PLAN COMMISSION MEETING AGENDA

TUESDAY, November 26, 2013
AT 6:00 P.M.

Plan Commission Report

PROJECT: Plan Review – Peter Caruso, Black Bear Bottling Group

TITLE SHEET

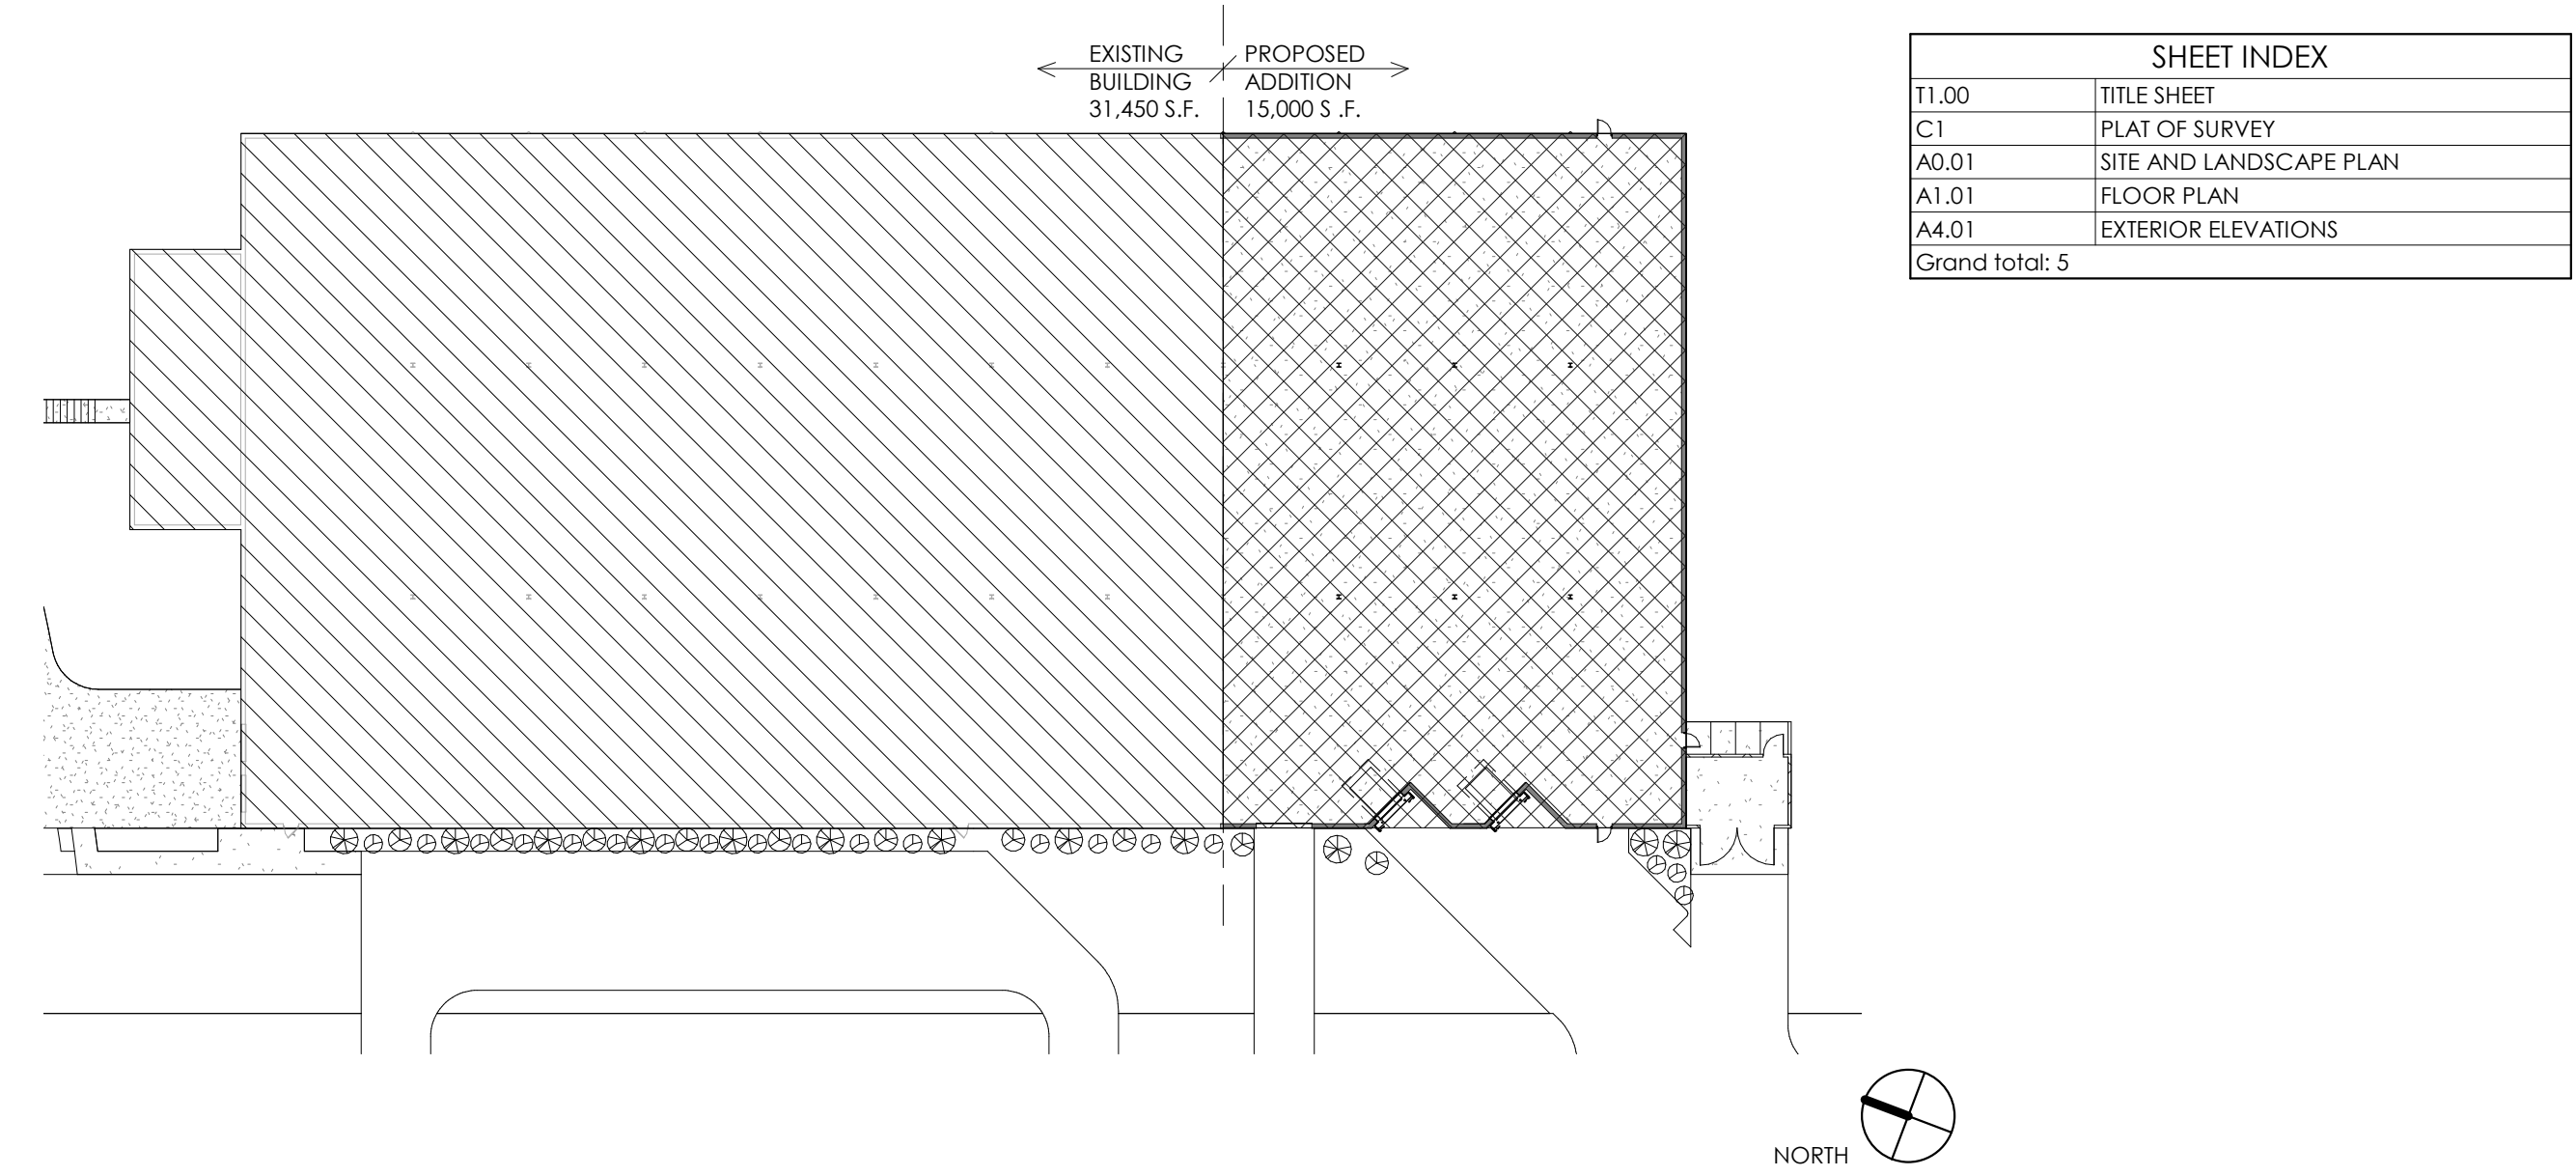
Over 50% of the property will remain as unpaved or green space following construction of the addition. Engineering has requested that the table on the Title Sheet include the percentage increase in impervious surface resulting from the addition and proposed parking, however, no stormwater plans are required at this time. Landscaping has been proposed along the proposed addition on either side of the loading docks (facing S. 20th Street). As there are no public entrances to the addition, this meets the requirements for landscaping adjacent to buildings. The dumpsters will be located behind a 6'8" enclosure that meets required setbacks.

SITE AND LANDSCAPE PLAN
A0.01

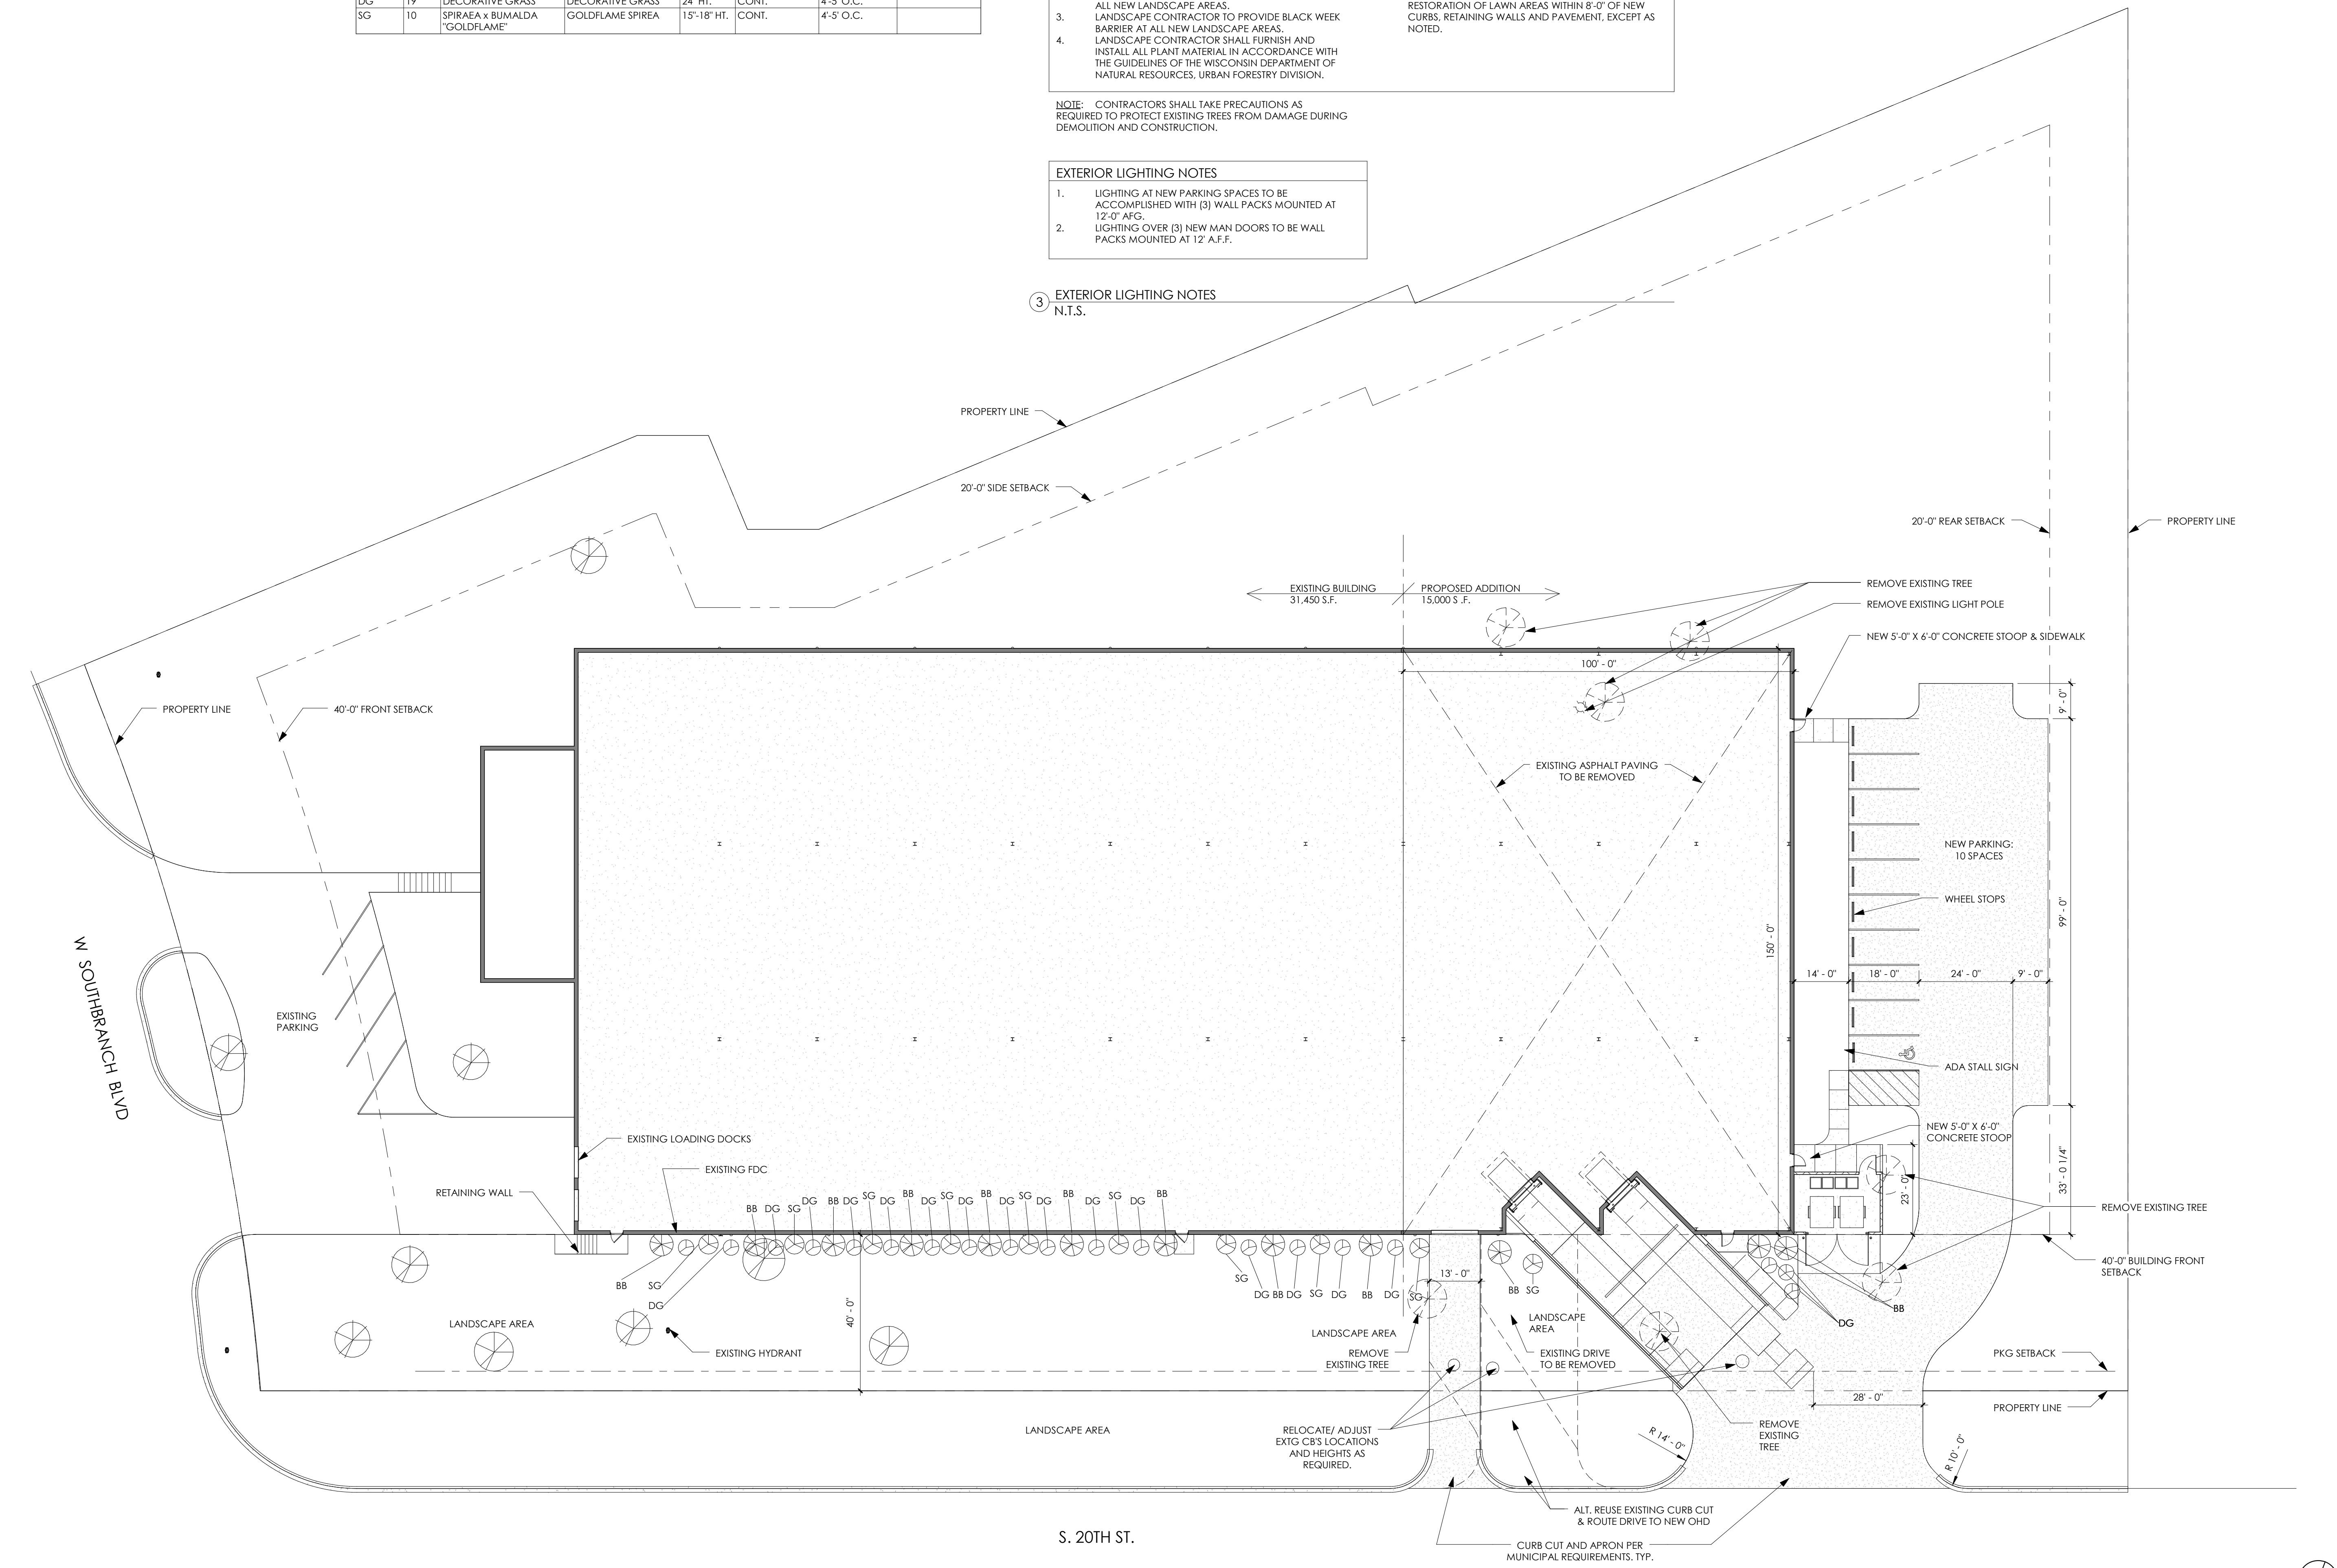
1. That all mechanical equipment is screened from view.
2. That all building and fire codes are met.
3. That a revised plan showing the utility easement on the western side of the property is submitted for review and approval by the Department of Community Development and Water Utility.

The Fire Department has commented that the building addition will be required to be sprinklered. The Water Utility has commented that the easement on the west side of the property is not shown on the plans.
